GRAND GULF NUCLEAR STATION, UNIT 1

AMENDMENT TO FACILITY OPERATING LICENSE

Amendment No. 41  
License No. NPF-29

ATTACHMENT TO LICENSE AMENDMENT NO. 41

FIGURE 3.1.5-1 SODIUM PENTABORATE SOLUTION TEMPERATURE/CONCENTRATION REQUIREMENTS

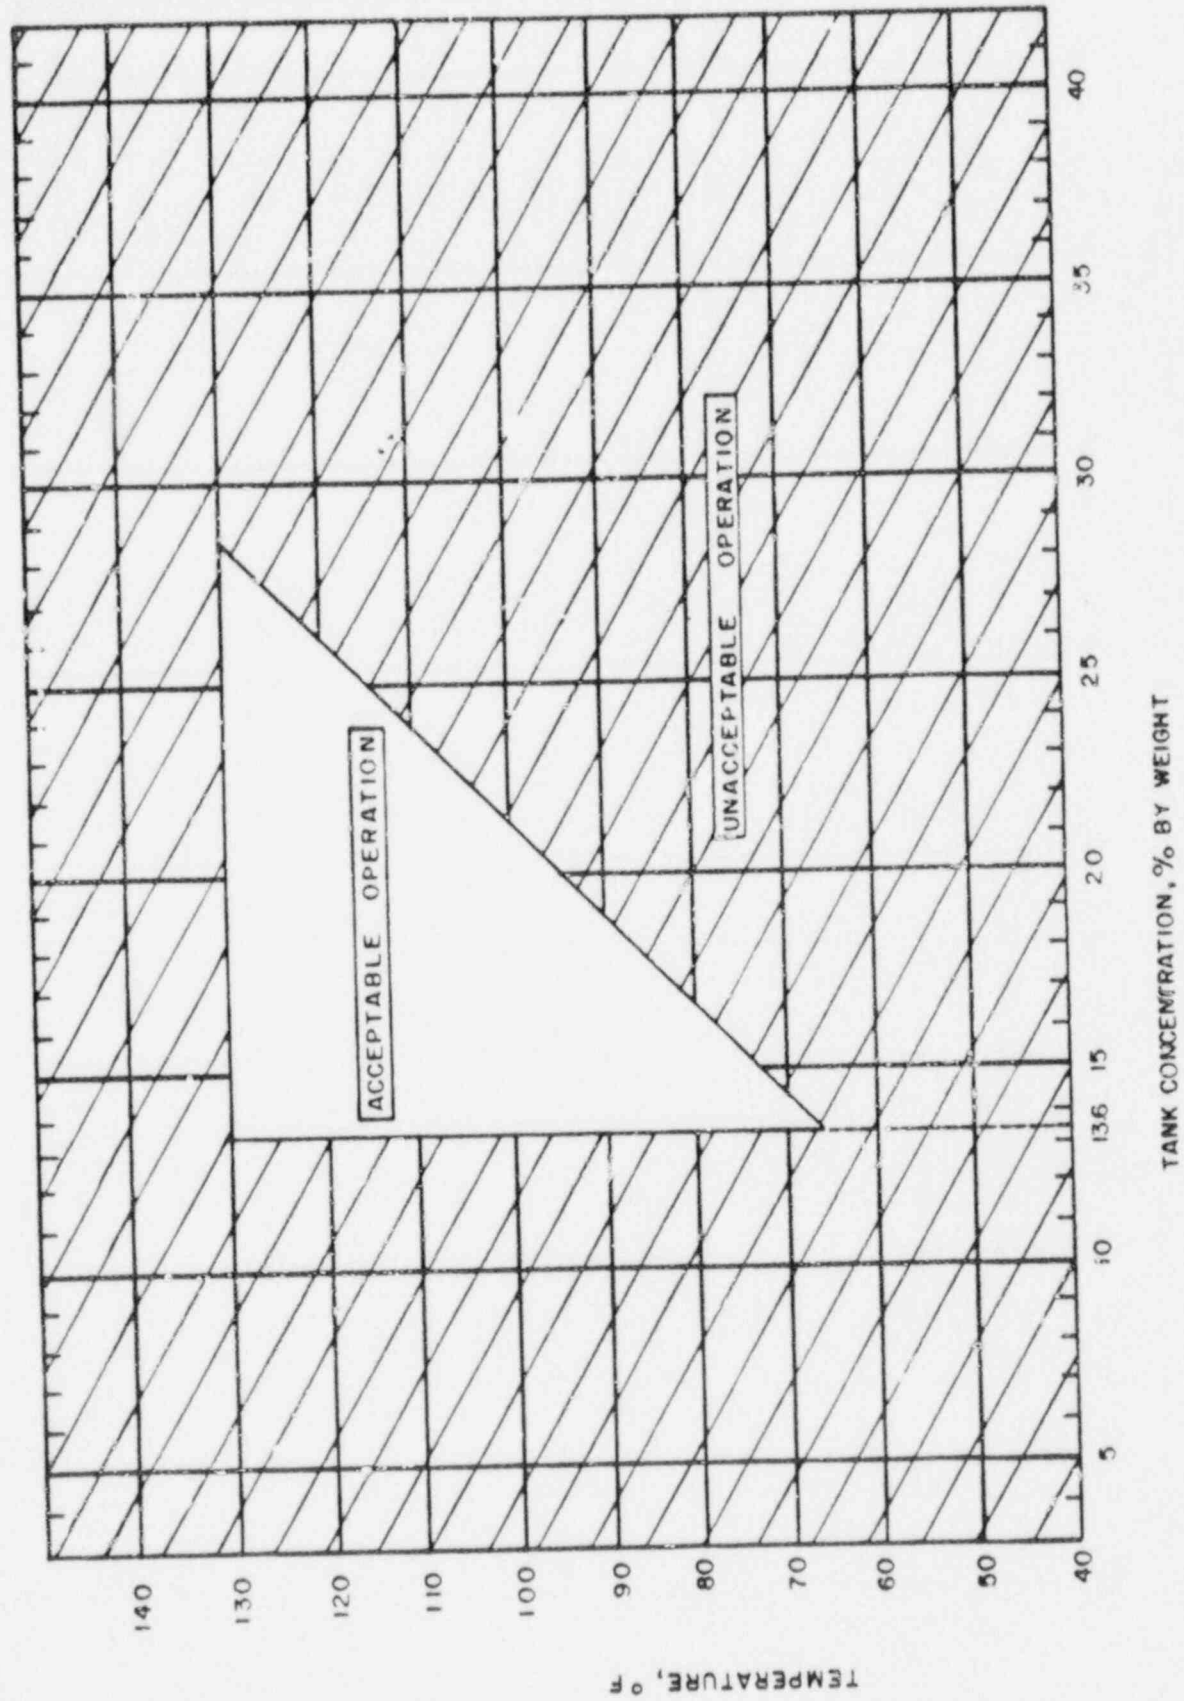
- a. At least once per 24 hours by verifying that;
  1. The temperature of the sodium pentaborate solution is within the limits of Figure 3.1.5-1.
  2. The available volume of sodium pentaborate solution is greater than or equal to 4530 gallons.
  3. The heat tracing circuit is OPERABLE by determining the temperature of the pump suction piping is within the limits of Figure 3.1.5-1.

- 3. Determining that the available weight of sodium pentaborate is greater than or equal to 5800 lbs and the concentration of boron in solution is within the limits of Figure 3.1.5-1 by chemical analysis.\*

\*This test shall also be performed anytime water or boron is added to the solution or when the solution temperature drops below the limit of Figure 3.1.5-1.
